**REQUEST**

Current Zoning: O-1(CD) (office, conditional)  
Proposed Zoning: O-1(CD)SPA (office, conditional, site plan amendment)

Approximately 1.27 acres located on the north side of Ballantyne Commons Parkway, east of Rea Road  
(Council District 7 - Driggs)

## PLANNING STAFF REVIEW

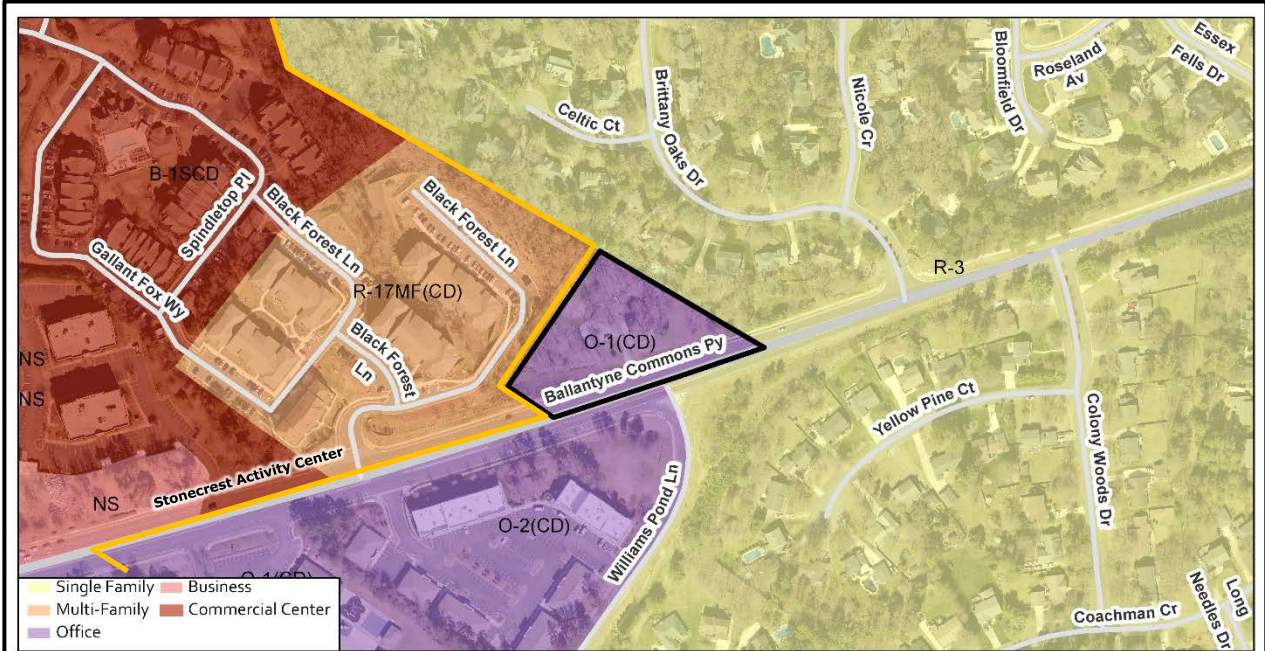
1. Expand Note 7 under Architectural Guidelines to state that the entry plaza will include pedestrian amenities such as, but not limited to, seating areas, art, water features and/or specialty landscaping.

2. Label the storefront entry and clear glass windows on the first floor of the building renderings.
3. Amend the buffer and label along the northwest property line to provide a 12-ft wide (16 feet reduced by 25% with the screening fence) Class C buffer, rather than 10 feet as shown on the site plan. In addition, add a note under Streetscape and Landscaping that reads "A 16' Class C buffer along the northwestern property line will be reduced to 12-ft with the provision of a 6' tall screen wall."

4. Amend the site plan to show a 16-foot Class C buffer along the northeastern property line rather than a 15-foot buffer. In addition, amend Note 12 to read "The 16' Class C buffer may not be reduced along the northeastern property line. A 6' tall screen wall will be provided along the northeastern property line."

5. Add a note under Streetscape and Landscaping that states "Petitioner agrees to provide an eight-foot planting strip behind the future back-of-curb along Ballantyne Commons Parkway."

6. Update the site plan to show two feet of right-of-way behind the sidewalk or show a two-foot easement behind sidewalk.

7. Add note that site must comply with the Tree Ordinance.

8. Amend Note 6 under architectural guidelines to correct the spelling of Ballantyne Commons Parkway, amend Note 17 under Transportation to correct the spelling of crossover, and change the word "designated" to "designed" in Note 18 under Transportation.
  9. Indicate the distance the future curb is from the centerline of Ballantyne Commons Parkway.
  10. Amend Note 10 under Streetscape and Landscaping to change the setback from 20 feet to 30 feet as shown on the site plan.
  11. Change the label for "large maturing trees" to "required street trees."
  12. Delete the last sentence of Note 10 under Streetscape and Landscaping because street trees are regulated by the Tree Ordinance.
-
